SUBJECT: Request for Public Hearing on February 12, 2019, at 2:00 p.m., for the Appeal of the Environmental Protection Commission recommendation of denial of an after-the-fact request for variance to side-setback for the Mathemeier dock permit application (#BD-18-05-056), for property located at 9184 Grand Island Way, on Lake Lartigue; Parcel ID No. 04-24-27-7555-05-100; District 1

**Dock Construction Application
Appeal of Environmental Protection
Commission Recommendation
BD-18-05-056
District #1**

Subject: **Scott Mathemeier Request for an After-the-Fact Variance for Dock Construction Permit BD-18-05-056**

MATHEMEIER SITE PLAN
 9184 GRAND ISLAND WAY
 WINTER GARDEN, FL 34787

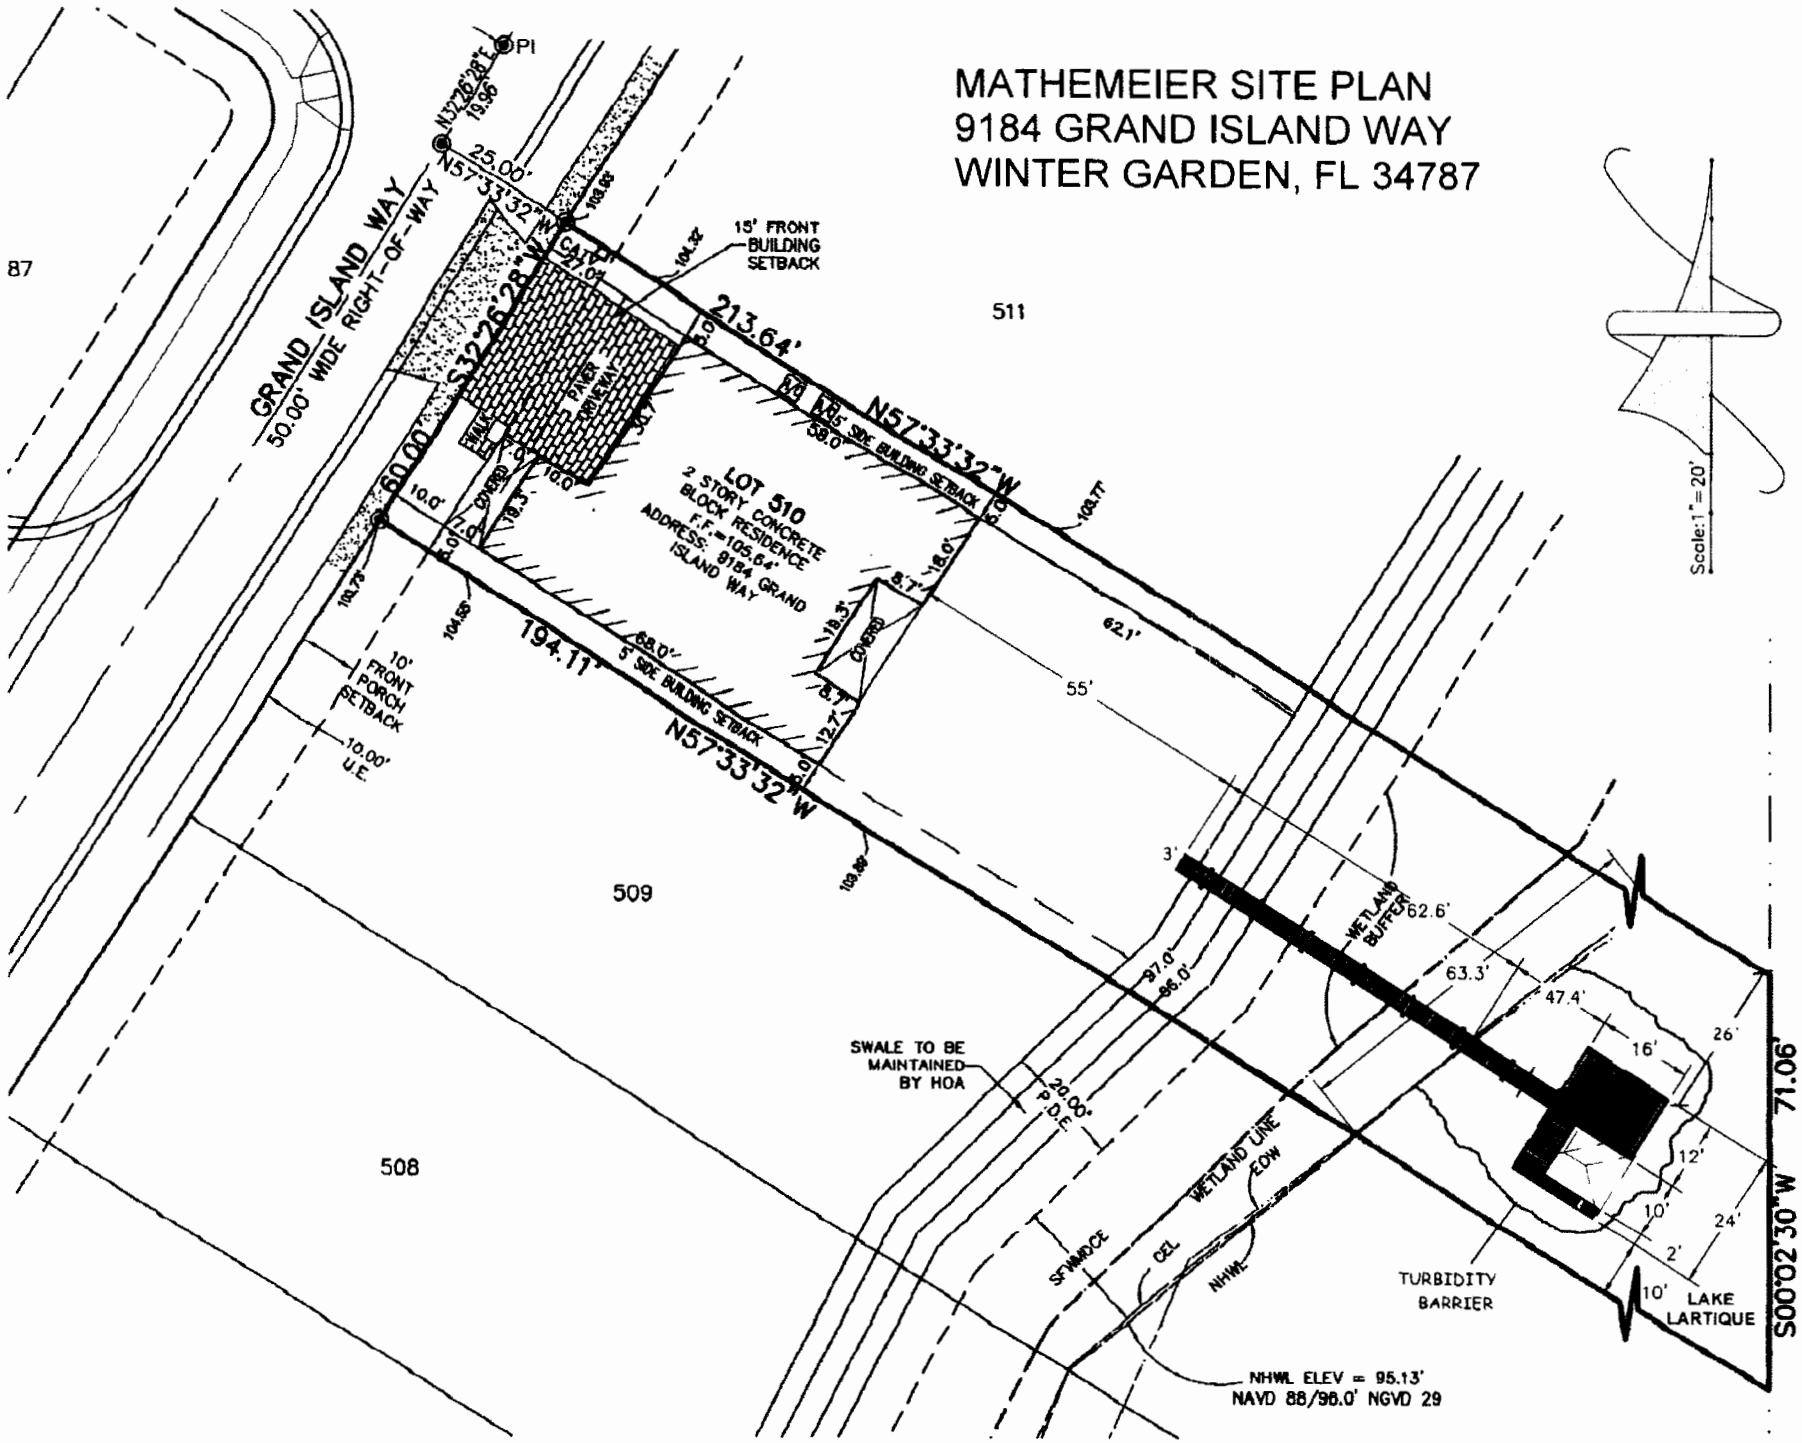
On July 16, 2018, EPD received an as-built survey of the constructed dock. During review of the as-built survey, staff noted that the side setback distance from the dock to the southwestern projected property line was only 5.4 feet, instead of ten feet as required by Orange County Code (Code). In order to keep the dock as constructed, an after-the-fact variance is required.

Chapter 15, Article IX, Section 15-343(a) of the Code states, "On lots or parcels having a shoreline frontage of less than seventy-five (75) feet, docks, including designated mooring areas, shall have a minimum side-setback of ten (10) feet from the projected property line." The shoreline of the subject property measures 63.3 feet; therefore, the side setback requirement is ten feet from the projected property lines.

The applicant has failed to meet 15-350(a)(1), therefore, the recommendation of the Environmental Protection Officer is to deny the after-the-fact request for variance to Section 15-343(a) (side setback).
